Outline Planning Approval Consultation

Application Number: 250517

Site Address: Land Off Basingstoke Road, To the south and west of Spencers W

MEMORANDUM

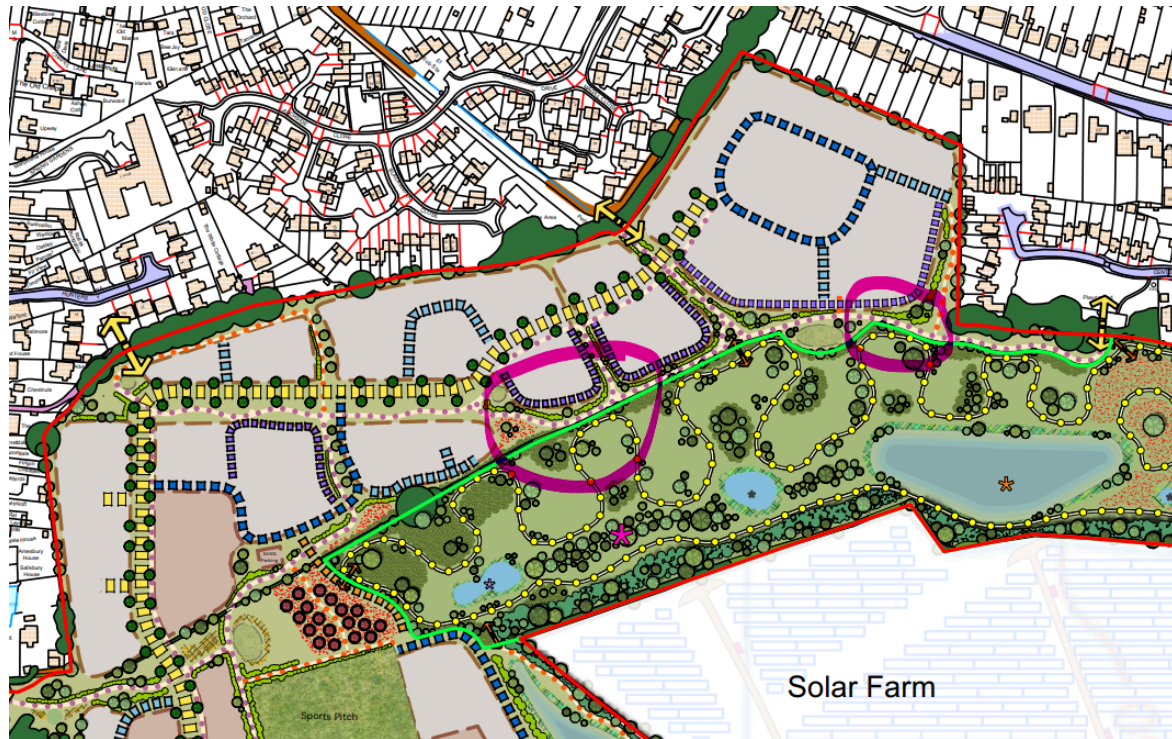
There are no public rights of way that are recorded within the site, however the development does link into Shinfield Byway 33 to the north.

The byway has not been marked on the illustrative masterplan however and details of the surfacing and barriers proposed at this location will need to be considered.

No details of barrier treatments between the proposed development and the byway appears to have been detailed. Similarly there does not appear to be details given as to any barrier treatments between the development and the SANG; it is recommended that the hierarchy of 'least restrictive option' and the

design requirements of any gates laid out in the British Standard for Gaps, Gates and Stiles (BS5709:2018) is adhered to.

With regard to the SANG, there does not appear to be sufficient access into the SANG, and there are opportunities to increase access points to enable easier access to the SANG for residents and also to meet likely desire lines. Please see sketch below:
